Planning Application 22/01131/FUL - 41 Lauder Road EH9 1UE

OBJECTION from Grange Association

7 April 2022

Plan view of proposals, showing loss of daylight to rear of 43 Lauder Road (Courtesy L Baggallay)

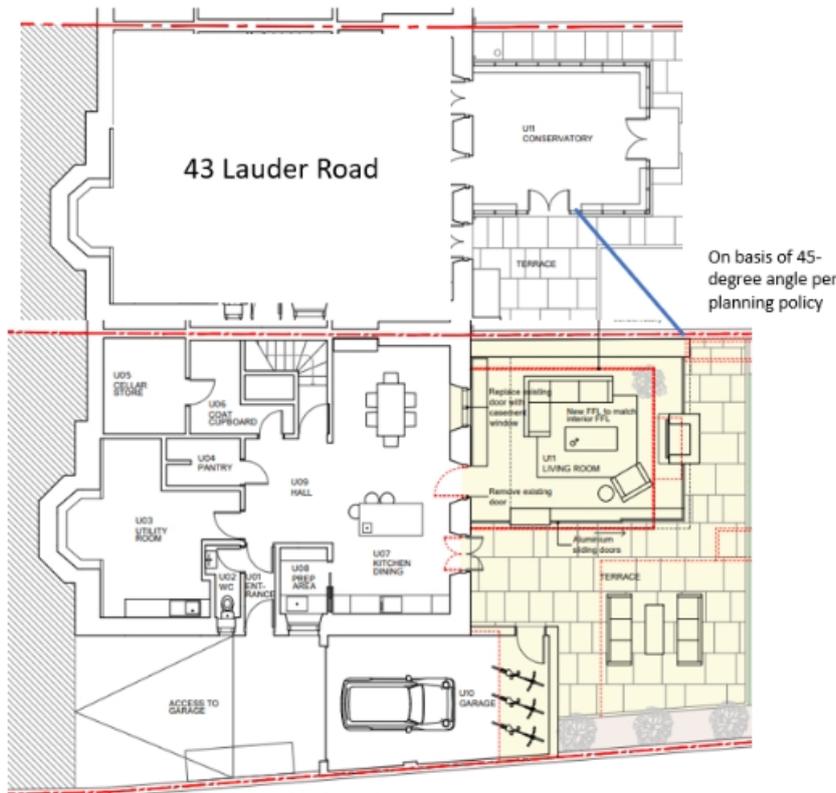
We are aware of the objection submitted by the neighbour at 43 Lauder Road and we endorse elements of that commentary, specifically with reference to the diagrams below which we reproduce to show the loss of daylight to the dining room and conservatory of that property.

The proposals for 41 Lauder Road would fail to maintain the daylight to the rear of 43 Lauder Road and would shade the dining room (the double doors) and the conservatory.

- Move the northern wall of the extension at least 3.4m to the south of the boundary; and
- Delete the chimney from the proposals.

Householder Guidance (Nov 2021), page 13

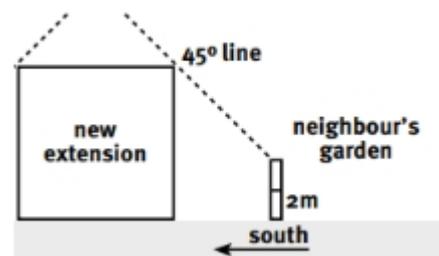
For this proposal, the extension will be 3.2m high abutting the boundary wall, built on ground already about 0.2m higher than the neighbour’s garden at 43 Lauder Road. For the 45 degree test to be met, the proposed extension’s northern wall would need to be relocated south, away from the site boundary wall, by at least 3.4m.

Proposed chimney on East wall of extension

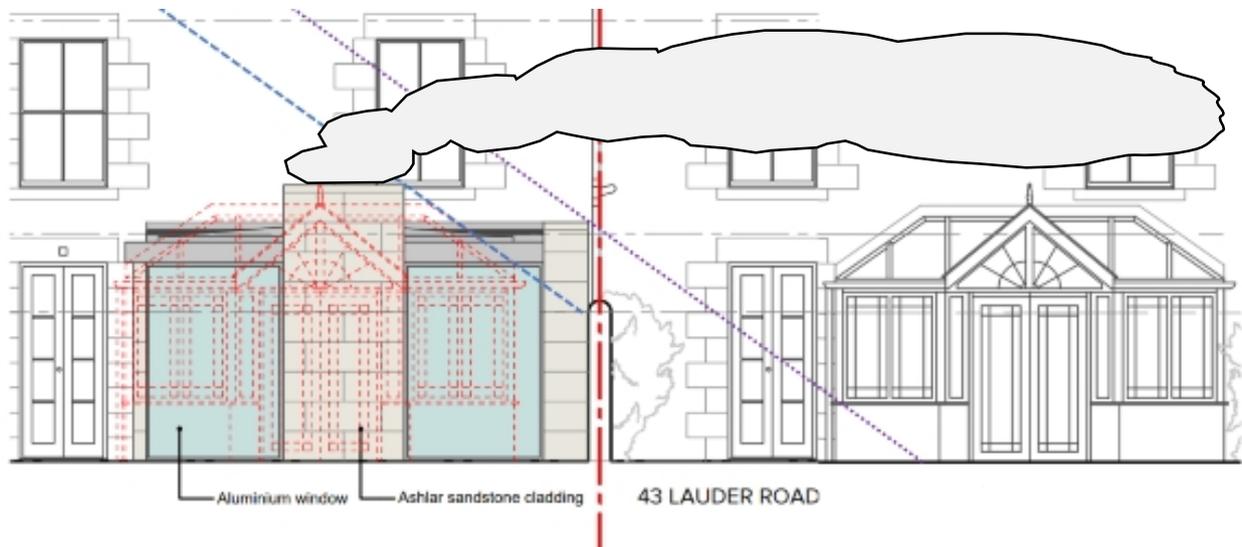
The plans include a chimney on the East wall of the proposed extension but give no details of the stove or fire for which the chimney is to be used. The exhaust fumes from any fossil-fuelled fire will be a nuisance to neighbours in their garden and when the first-floor windows are open and we request that the chimney be removed from the proposals.
